**PLANNING AND ZONING COMMISSION OF JEFFERSON COUNTY, MISSOURI
NOTICE OF MEETING**

Petition Number: VR22043

NATURE OF REQUEST: Relief from Section 400.2530 C – Driveway Offsets, Section 400.2560 – Minimum Pavement Standards, Section 400.2610 – Driveway Requirements – Width, Section 400.4100 A.5. – Parking, Loading, and Storage Lot Area Improvements, Section 400.4650 A – Street Frontage, Section 400.4650 B – Open Yard Areas, Section 400.4690 – Parking Lot Landscaping and Trees, Section 400.4700 – Parking Lot, Screening, Section 400.4100 A.2. – Vehicle Parking Spaces, and Section 400.2460 – Lighting Standards.

Re: The Annex, 6482 State Road MM, House Springs, MO 63051

ANTONIA RIDGE ESTATES Preliminary Plat

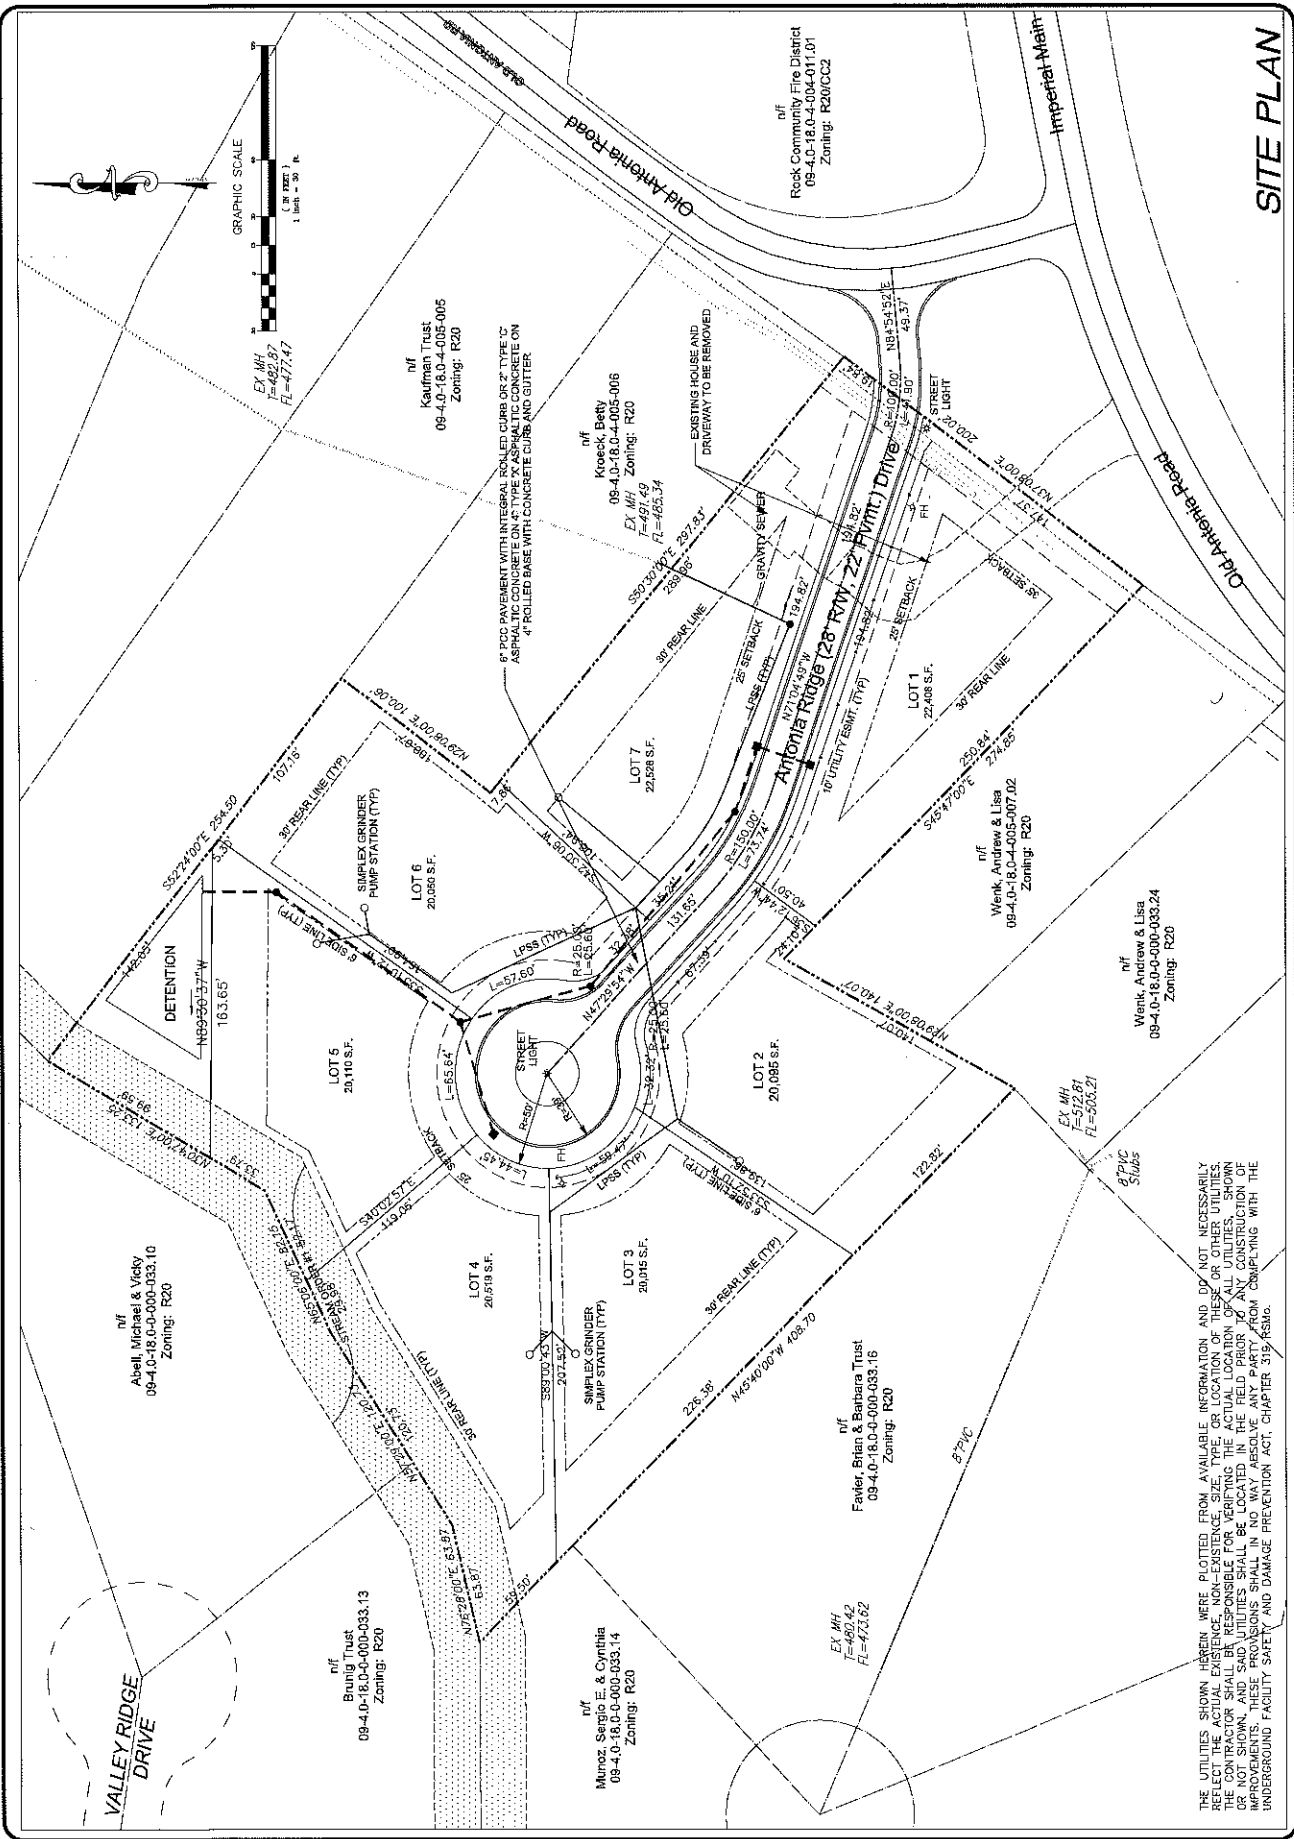
- 1) County Road:
 - a) Access onto a county road shall require 300' of stopping sight distance at 3.5' height of eye and 4.25' height of oncoming vehicle (minimum 1' of clearance between line of sight and surface/top of grass).

- b) The Engineer shall submit sight distance profiles showing that the required sight distance is met.
 - c) The engineer shall identify the clearance at the most restrictive point on the profiles.

- 2) Streets:
 - a) Corner clearance is required for any driveway along a street that accesses a county road. The required 125' clearance is not met. A deviation has been applied for and reviewed.

- b) Streets shown with 22' pavement within 28' ROW with curbs are acceptable if posted for no parking on both sides. If parking is desired on one side, then a 28' wide pavement in a 40' ROW is required.

- c) Street thickness shall include 6" PCC or 2" Type C Asphaltic Concrete/3" Type X Asphaltic Concrete/4" rock base.
 - d) Streets shall not exceed 14% grades, 100' horizontal radii, K=20, 0' tangents, and 1500' block length.

- a) Sidewalks shall consist of 5' width.
- b) Sidewalks required on both sides of road and around cul-de-sac.
- 4) Stormwater/detention:
 - a) Stormwater shall be detained and released at a rate not to exceed the release rate from the site under the existing (pre-developed) conditions for the 2 and 100-year storm events. Detention/retention basins must also contain an overflow structure capable of passing a 100-year, 20-minute design storm.

- b) Channel protection is required channel protection to treat the high-frequency, low-severity storm runoff events within the detention basins by metering it out slowly over 24-48 hours.

- c) Stormwater system shall be designed for the 15-year, 20-minute event. Provide hydraulic calculations and drainage area map for each system.
- 5) Stream Buffers:

- a) The Stormwater Division requires that stream buffers be maintained for stream orders 1, 2 and 3 as required by Section 505.170-B-3 of The Jefferson County Stormwater Design Manual.

I have reviewed the preliminary plat of this development as requested. The only concern I have is that the proposed Antonia Ridge Drive is only about 50'-55' from the Old Antonia Road intersection with Imperial Main Street.

THE ANNEX
6482 STATE HWY MM, HOUSE SPRINGS, MO 63051
Site Plan and Details

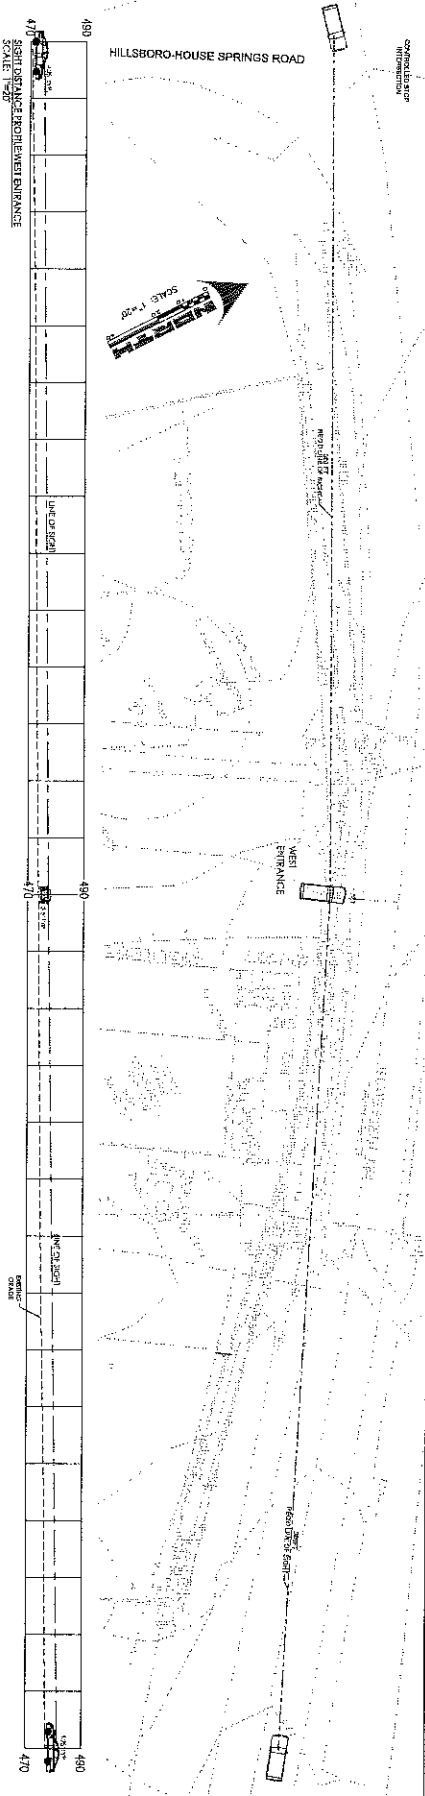
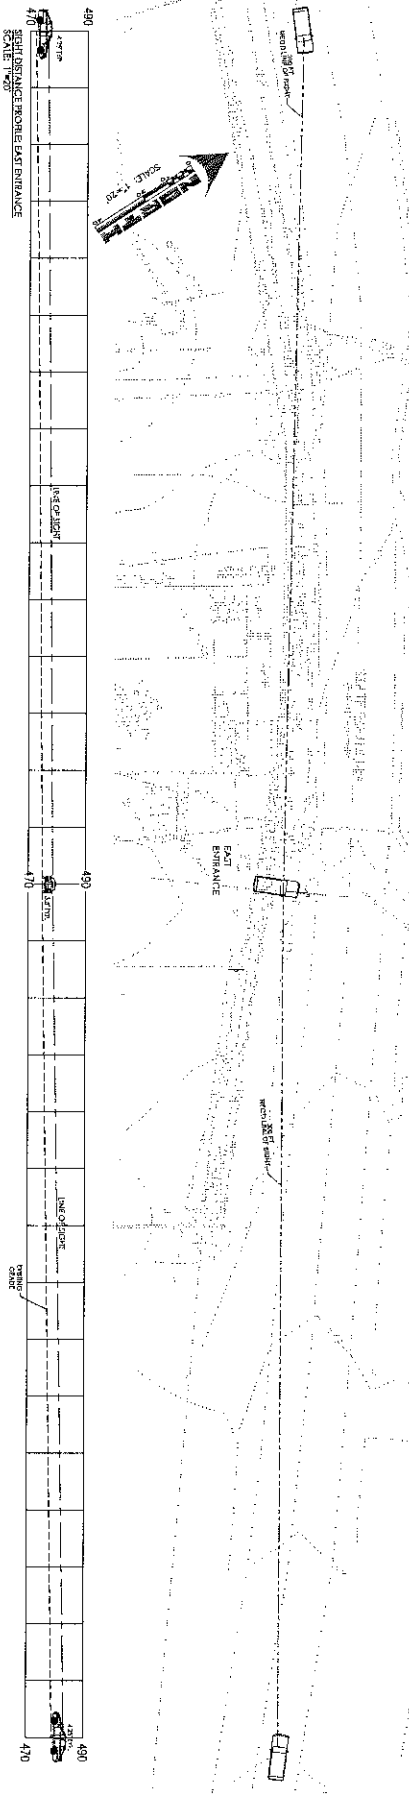
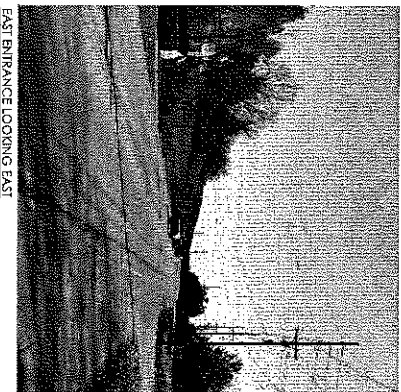
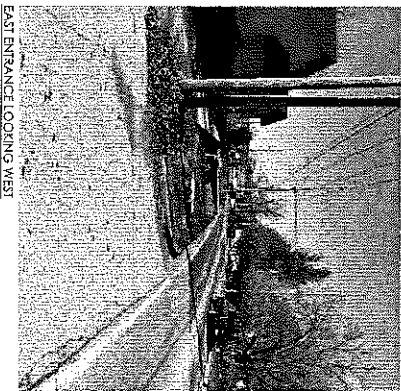
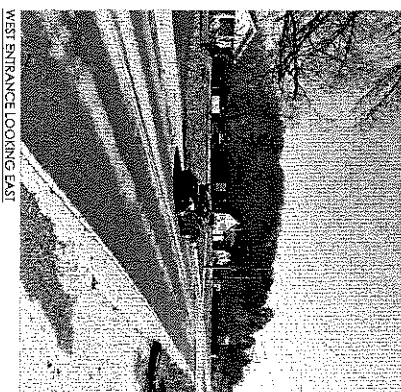
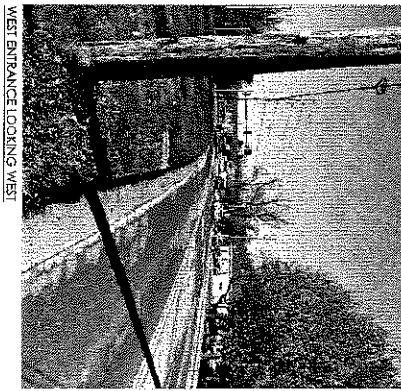
Analysis**1. Section 400.2530 C – Driveway Offsets**

Petitioner cannot meet the 125' offset requirement due to existing driveways on properties surrounding the subject property. There is no alternate location which will not create offset conflicts.

2. Section 400.2560 – Minimum Pavement Standards

The UDO requires an entrance pavement thickness of 6" PCC (or 2" Type C Asphaltic Concrete/4" Type X Asphaltic Concrete/4" rock base). The existing thickness is unknown. The pavement is in deteriorated condition and should be removed and replaced.

The existing drives are 22' wide and 20' wide respectively. They connect to a very wide shoulder on Highway MM that facilitates turning movements. There should be no loss of traffic flow due to granting this request.

Parking areas with 5 or more required parking spaces must provide a paved surface of 3" Type C Asphaltic Concrete over an 8" rock base (or 2" Type C Asphaltic Concrete/4" Type X Asphaltic Concrete; or 6" PCC). The thickness is unknown. The existing pavement is in deteriorated condition and should be removed and replaced.

As the property exists today, there is no street frontage landscaping. While there is existing vegetation on the property, it is not located within the front of the property. Staff recognizes that right-of-way width for State Rd MM may not allow the area needed for street frontage landscaping located in front of the building; however, there is plenty of street frontage on both sides of the building that provides adequate room for landscaping. It should be noted that street frontage landscaping can be clustered, per the UDO, which makes the implementation of street frontage landscaping achievable while avoiding conflict with the front of the existing building.

The petitioner has stated that the existing vegetation will not be removed. The existing vegetation consists of a large tree mass along the western property line and partially along the southern property line. There are also a few trees scattered within the eastern portion of the property. If the existing vegetation does not satisfy Open Yard landscaping requirements, there is open space within the property that could allow for additional landscaping.

The UDO states that landscaped parking islands shall be provided to accommodate fifty (50) or more cars. Per the submitted site development plan, fifty-five (55) parking spaces are provided.

This section of the UDO states that a visual screen shall be provided if the parking lot accommodates fifty (50) or more parking spaces. As stated above, fifty-five (55) parking spaces are shown on the site development plan. The subject property has allowable space for parking lot screening.

The ROW of State Highway M is 60' at this point. The proposed spaces are all over 20' from the edge of traveled pavement. There is a wide shoulder here and granting the request should present no concerns for traffic movements or sight distance.

Per the UDO, commercial developments are required to provide a photometric plan to ensure lighting is adequate and covers the surface of the parking lot in its entirety.

Should the Planning and Zoning Commission vote to approve this request, Staff recommends the request to be conditioned, at a minimum, to receive a pavement preservation such as a chip seal or a 2" overlay (after some pothole/base repair).

Should the Planning and Zoning Commission vote to approve this request, Staff recommends the request to be conditioned, at a minimum, to receive a pavement preservation such as a chip seal or a 2" overlay (after some pothole/base repair).

Should the Planning and Zoning Commission vote to approve this request, Staff recommends the request be conditioned that Petitioner cannot remove any of the existing vegetation.

Should the Planning and Zoning Commission vote to approve this request, Staff recommends the request be conditioned that the site development plan show the location of the existing lights which illuminate the parking lot. During the site development process, Staff has allowed some infill commercial developments to provide location of existing lighting, proving that the lighting is adequate.

- 1)a) The proposed development is a reuse/repurpose of an older, existing building; the building and site layout (parking, entrances, etc.) proved functional for many years as a Lions Den Hall. In the not-to-distant past, reconstruction of State Route MM found no reason to relocate these existing entrances. Plus, Mr. Schatz's proposed use of the facility will have less occupancy, and thus fewer vehicles entering and exiting the facility.

- 1)b) As mentioned above, the existing entrances and parking lot have been in place for many years and adequately serviced the prior use...there is no evidence of pavement deterioration beyond what more frequent, prior pavement maintenance would have addressed. It is noted that Mr. Schatz will be conducting a small test excavation of the existing pavement cross section to record the depth of paving materials. Regardless of those findings, based upon the proven serviceability of the existing pavement, Mr. Schatz proposes to mill and overlay the existing pavement while maintaining the existing surface elevations to the maximum extent practicable.

- 1)c) As mentioned above, the existing parking lot proved adequate and serviceable for many years and prior uses. This current proposal looks to maintain that functionality, retaining the existing geometry.

- 7)b) As depicted on the site plan and existing conditions surveys, there is generous open yard areas (including mature trees) on the site. Mr. Schatz does not propose any reduction to what now exists, and looks to maintain what has seemingly proven very adequate over many years of prior use.

- 7)c) Consistent with our rationale for the above-listed requests, we look to maintain the prior character and serviceability of the existing site layout through re-use of what now exists. It is our opinion that removing existing pavement to introduce planting(s) interior to the parking lot would not enhance what has been in place for many years, in no small part recognizing the existing mature landscaping in very close proximity to the edges of the in-place parking lot.

- 7)d) With the exception of the east property line (*along which exists a commercial/industrial driveway accessing a Jefferson County service garage / maintenance facility*), dense vegetation/ hedgerow exists along the west (side yard) and south (rear yard) of the property. This vegetative growth provides screening...it has for many years. Regarding the east property line, yes it is "wide open" to the commercial driveway, but Mr. Schatz is comfortable with that condition, is confident it will not impair his proposed reuse of the facility, and there should be no concern that lack of a screened buffer on this line would negatively impact the use, operation or character of the driveway accessing the County maintenance yard.

- 8) As explained above, the geometry of the parking lot has proven functional for many years. Considering the fact that the proposed use will have fewer patrons than the Lions Den hall, it seems reasonable that allowing the parking spaces to remain "as is" would not be a detriment to public health, safety or welfare. Mr. Schatz is not proposing to expand or increase the degree or extent of any "non-conformity"...simply looking to return a now-vacant property to productive use, while retaining the character of a facility that served the community for many years.

- 9) The site lighting that is now in place (*consistent with other components of the existing site plan, as described above*) adequately served the prior use and our proposal is to simply retain what is now there. It is also noted: the proposed hours of operation do not extend late into the evenings; the existing lighting has relatively large setbacks to adjoining properties; adjoining properties are, for the most part, commercially-zoned (or used); adjoining residential uses are located either across State Route MM, or at the southwest corner of the parcel (somewhat remote).
